# ACCELERATED DISTRIBUTION DEMONSTRATION SYSTEM

SUBJECT: Responds to 931026 RAI re power uprate review.

Subject: **WNP-2, OPERATING LICENSE NPF-21  
RESPONSE TO REQUEST FOR ADDITIONAL INFORMATION,  
POWER UPRATE REVIEW (TAC M87075)**

Reference: Letter, dated October 26, 1993, JW Clifford (NRC) to JV Parrish (SS), "Request for Additional Information, Power Uprate (TAC No. M87075)

Power Uprate MCPRf Curve  
GE Nuclear Proprietary

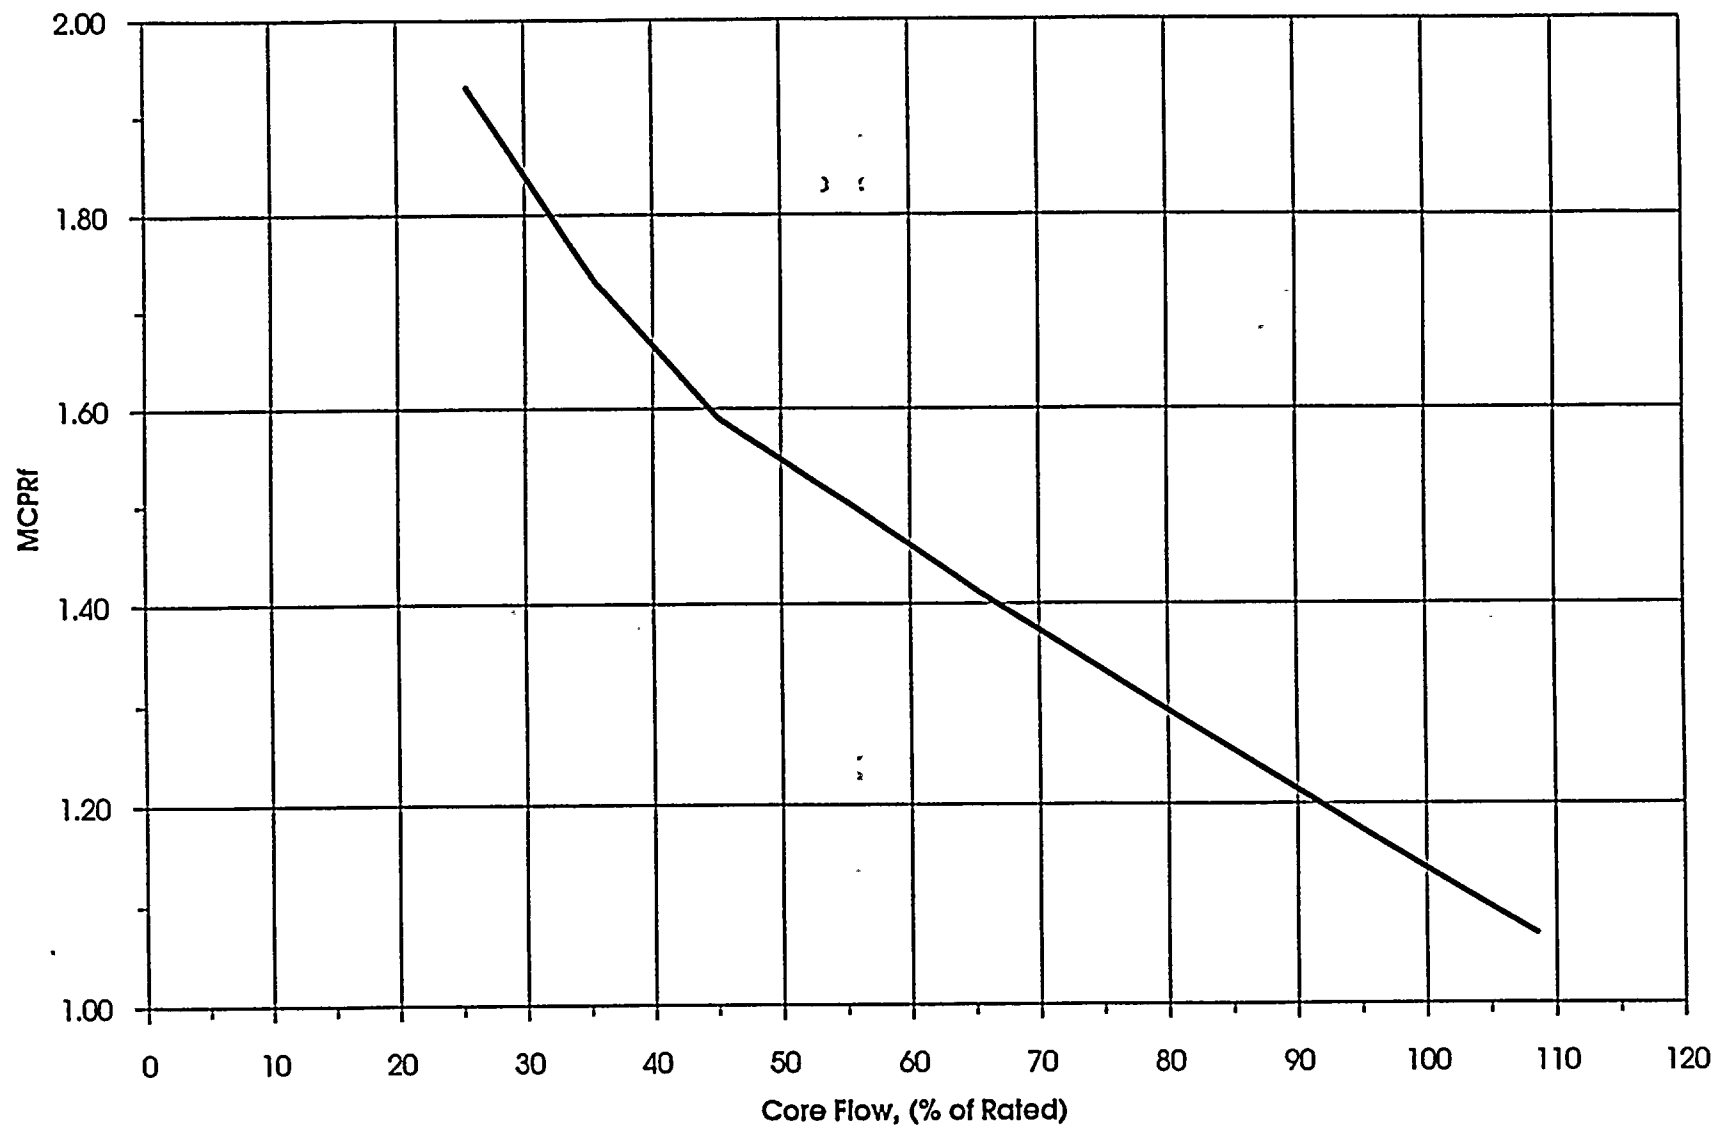
6. *The transient analysis results for uprate are presented in Table 9-2 of NEDC-32141P. Please define  $MCPR_f$  for the  $\Delta MCPR$  column for the Slow Recirculation Increase transient.*

The analysis of abnormal operational occurrences for BWR core reloads is generally performed assuming rated and/or maximum allowable core flow conditions. The purpose of the  $MCPR_f$  curve is to adjust the MCPR operating limits when the plant is operating at less than rated core flow. This is necessary because some transient events are more severe (i.e., larger  $\Delta MCPR$ ) when initiated at reduced core flow. In the manual flow control mode, similar to WNP-2, the  $MCPR_f$  curve assures that the safety limit MCPR will not be violated should the most limiting (e.g., flow increase) transient occur.

The transient analysis performed for WNP-2 with RRC valve flow control included analysis of the  $MCPR_f$  curve for WNP-2 for cycle 8 for uprate conditions. A copy of this curve is attached. The cycle specific Slow Flow Runout Event analysis and the corresponding  $MCPR_f$  will be completed for the specific reload cycle in which power uprate is to be initiated by the Supply System and its fuel vendor. The results of the analysis will be shown in the Core Operating Limits Report of the specific fuel cycle.
